#### SCHEDULE OF CHANGES

Rev.	Date	By	Ckd	Description
G	17/08/2023	WN	DN	S4.56 Issue 2

30 Fairlight St, Fairlight  
30 Fairlight St,  
Fairlight, NSW 2094

DA403  
G

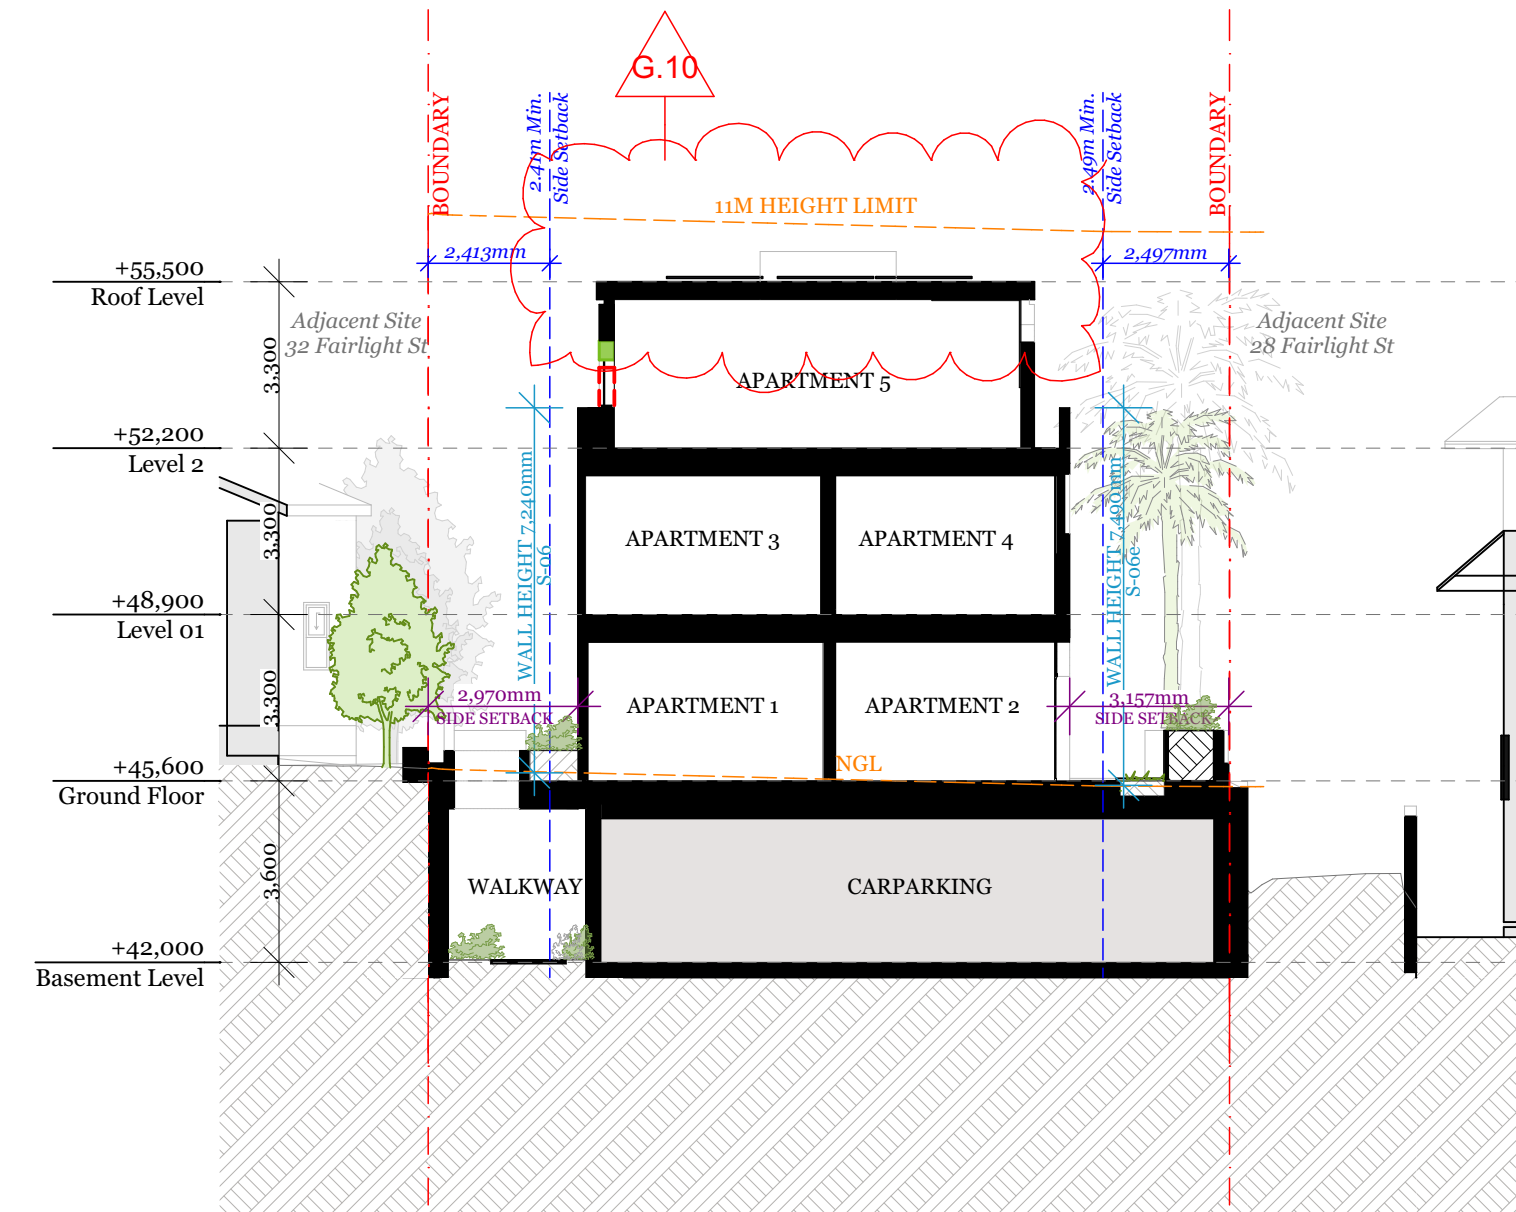
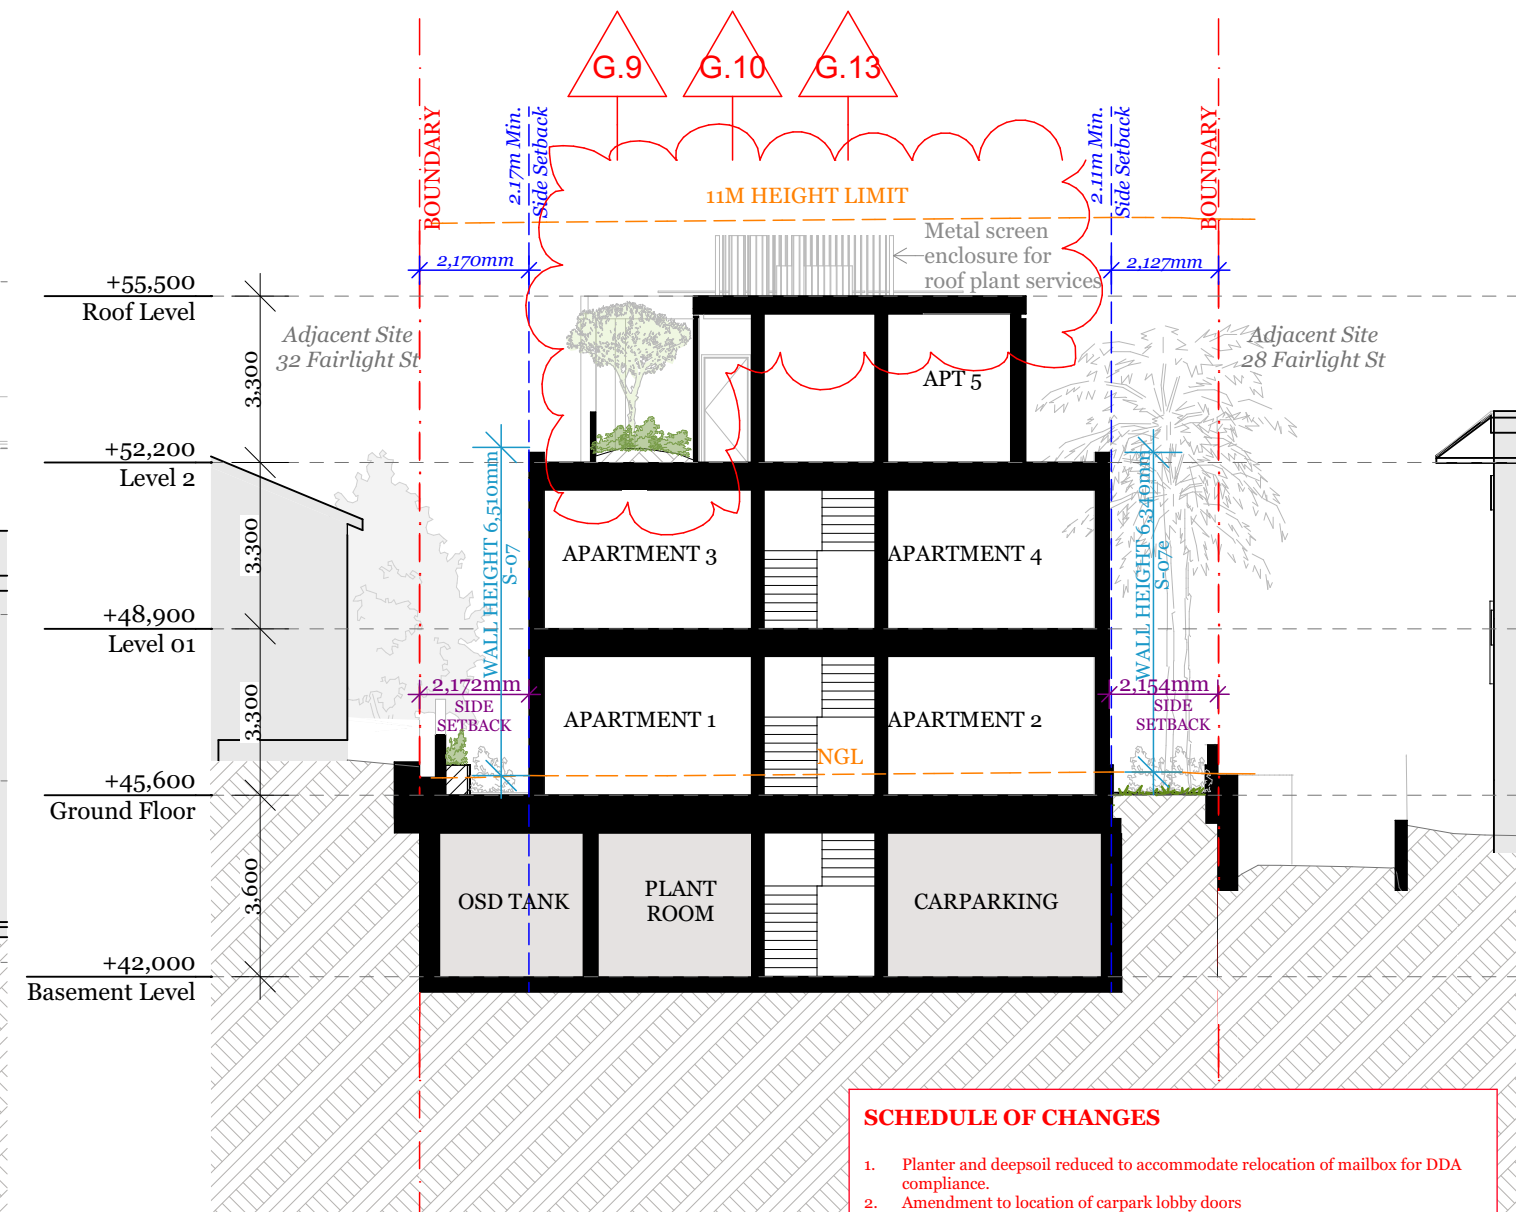
1. Planter and deepsoil reduced to accommodate relocation of mailbox for DDA compliance.
2. Amendment to location of carpark lobby doors
3. OSD tank extended to accommodate minimum volume as per Stormwater Engineer's report.
4. Additional door added for compliance as alternate fire egress with NCC D2D6.
5. Landscaping and planter replaced with terrace hardscape to accommodate OSD tank volume below.
6. Wall of front terrace rationalised for buildability
7. Window opening reconfigured.
8. Internal layout reconfigured and rationalised
9. Plant services added onto roof including AC condensers, hot water units and mechanical vent exhausts to be concealed with metal screen enclosure
10. PV panels added.
11. Skylights deleted.
12. Solid access hatch cover amended to glazed hatch.
13. Courtyard landscape amendment.

DA404  
G

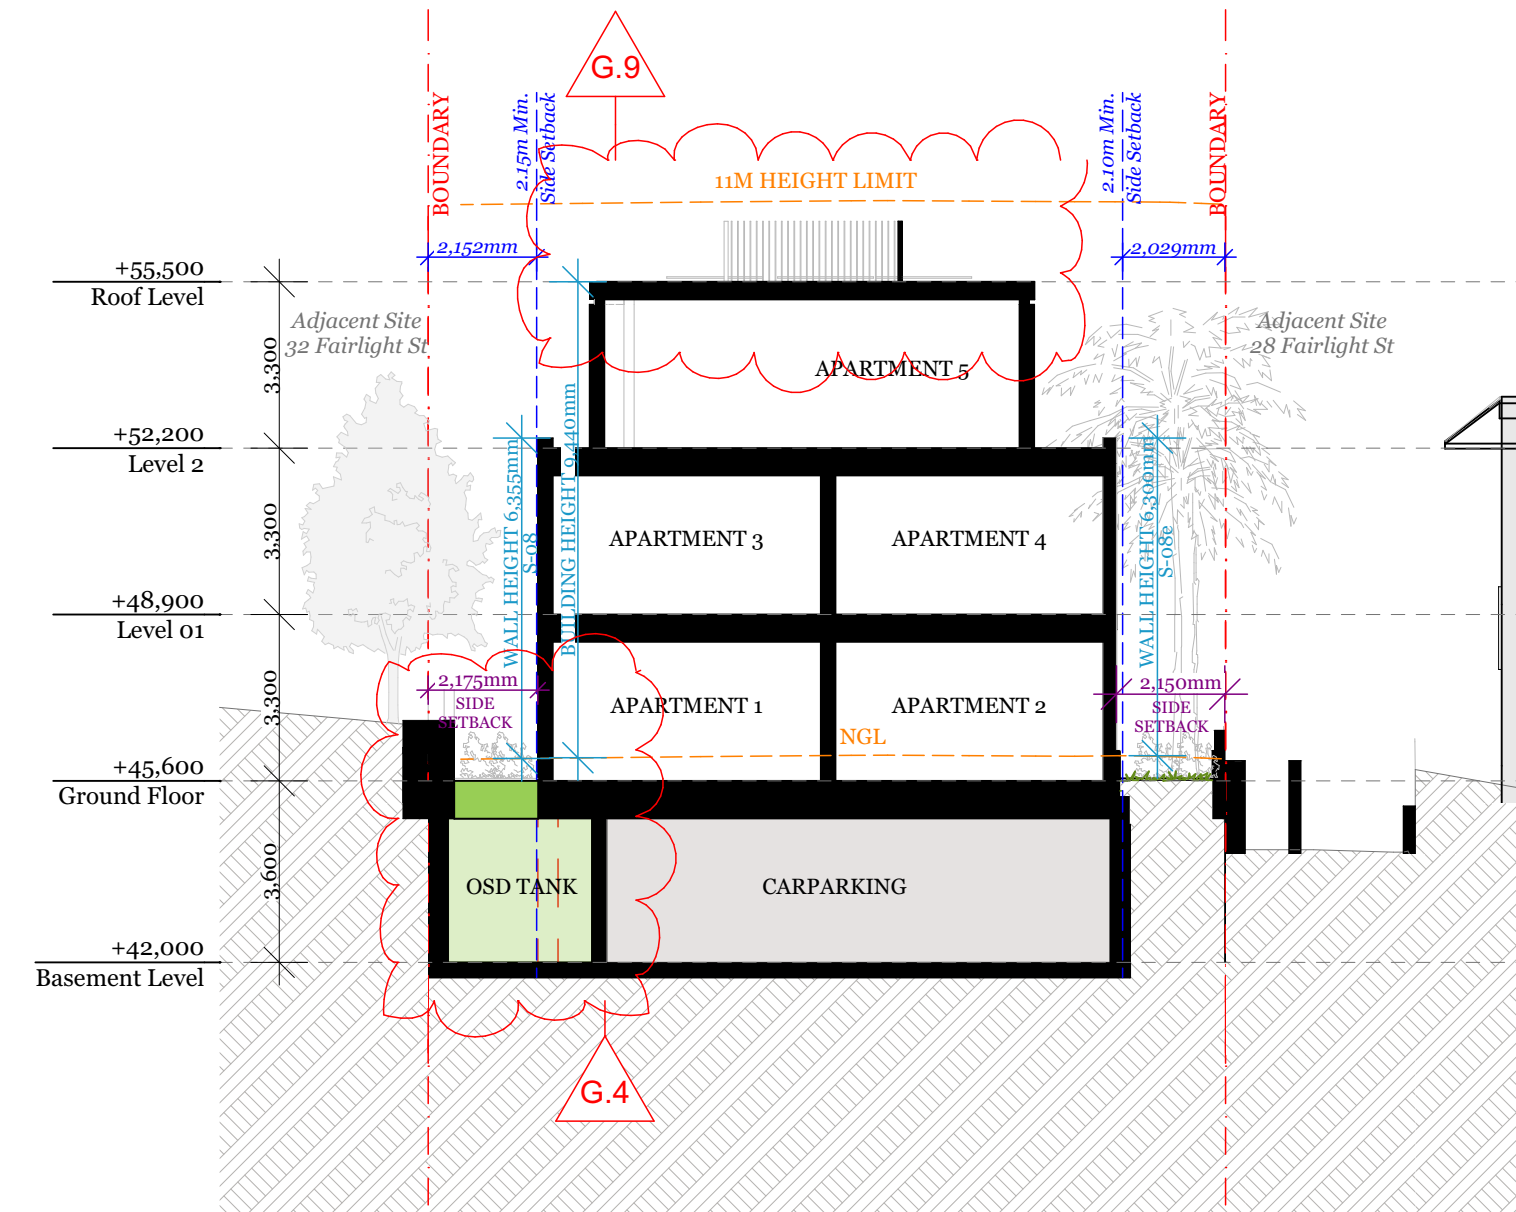
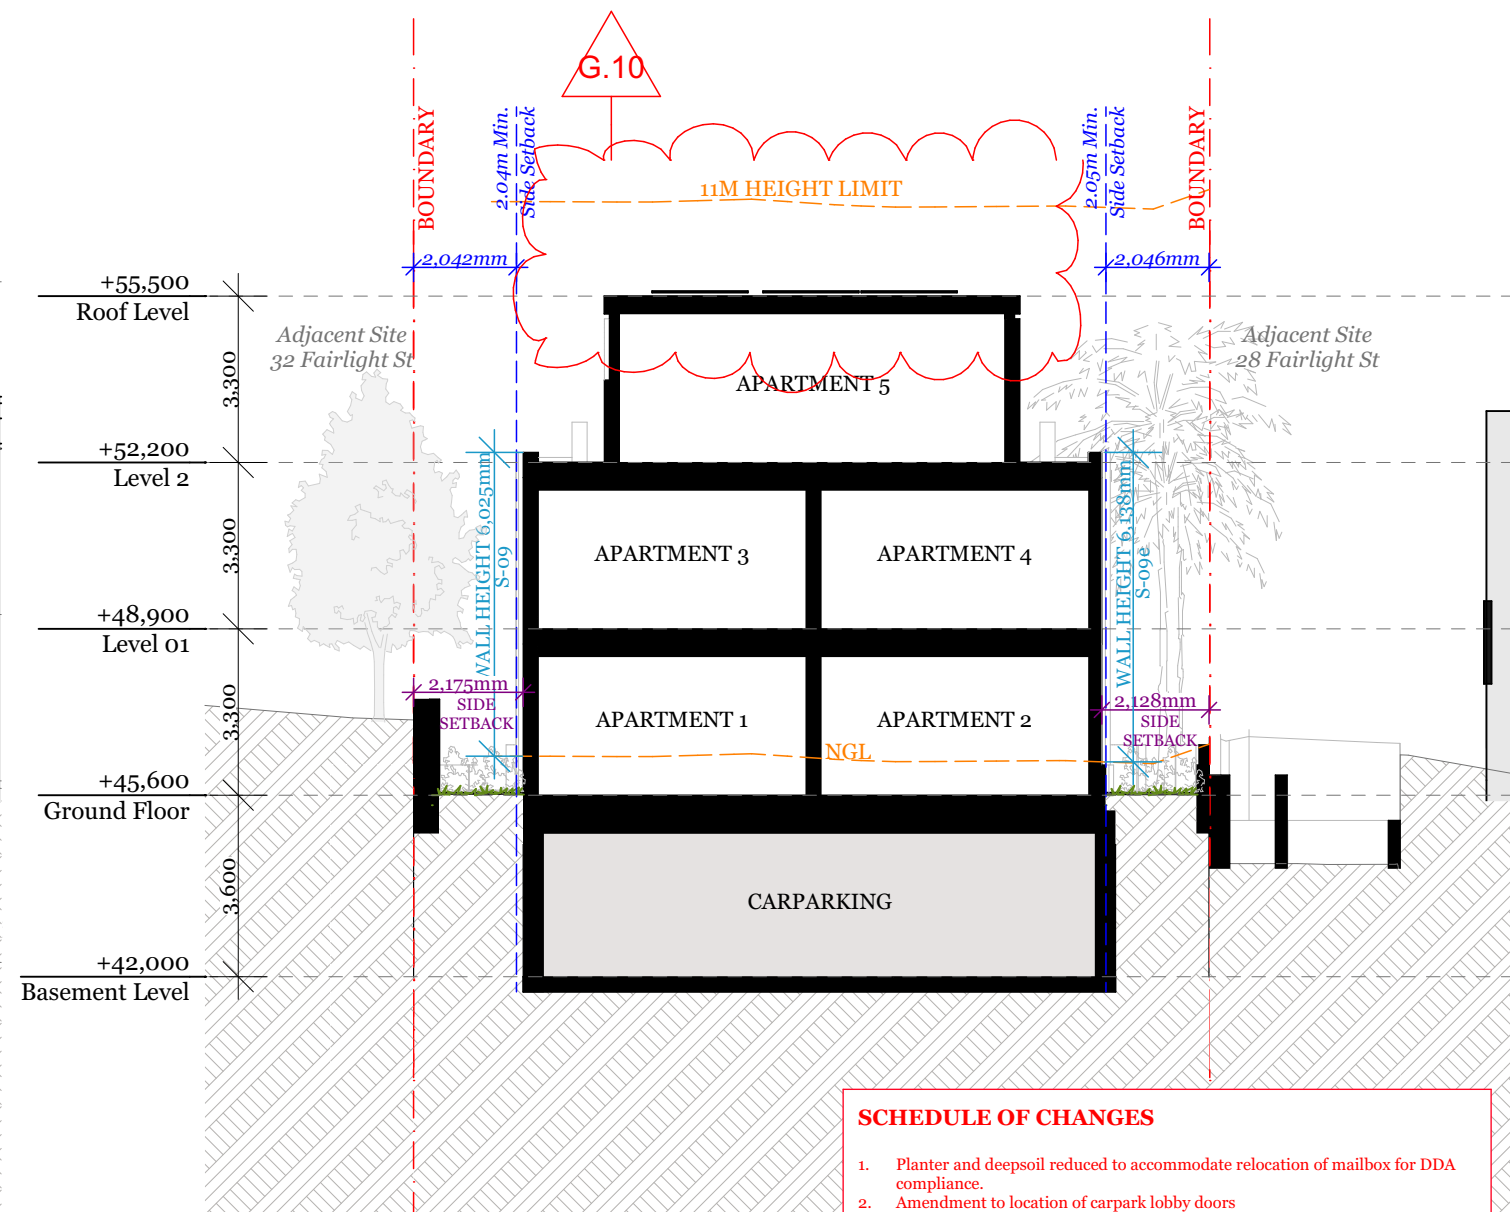
1. Planter and deepsoil reduced to accommodate relocation of mailbox for DDA compliance.
2. Amendment to location of carpark lobby doors
3. OSD tank extended to accommodate minimum volume as per Stormwater Engineer's report.
4. Additional door added for compliance as alternate fire egress with NCC D2D6.
5. Landscaping and planter replaced with terrace hardscape to accommodate OSD tank volume below.
6. Wall of front terrace rationalised for buildability
7. Window opening reconfigured.
8. Internal layout reconfigured and rationalised
9. Plant services added onto roof including AC condensers, hot water units and mechanical vent exhausts to be concealed with metal screen enclosure
10. PV panels added.
11. Skylights deleted.
12. Solid access hatch cover amended to glazed hatch.
13. Courtyard landscape amendment.
